## Access Compliance Report Public Rights-of-Way (Curb Ramps)

Intersection ID: 25477 Main Street: FIVE\_KNOLLS\_DR Cross Street: REA\_RD Location: NW

ADA ID: EF851540C034 Ramp Type: Directional1 Initial Pass/Fail: Pass Overall Compliance: No Severity Score: 0

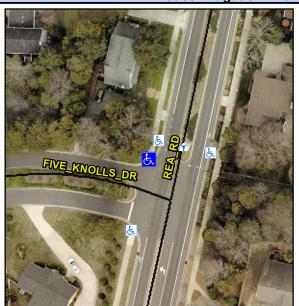
R304.2.1, R304.5.3

| Compliance Description Data Compliance Description Data |                       |       |     |                             |      |
|---|-----------------------|-------|-----|-----------------------------|------|
| Yes   | Ramp Width (in)       | 68.5  | No  | Grade Break Slope (%)       | 5.7  |
| No  | Landing Length (in)   | 38.0  | Yes | DWS Provided?               | Yes  |

Remove & Replace Entire Ramp.
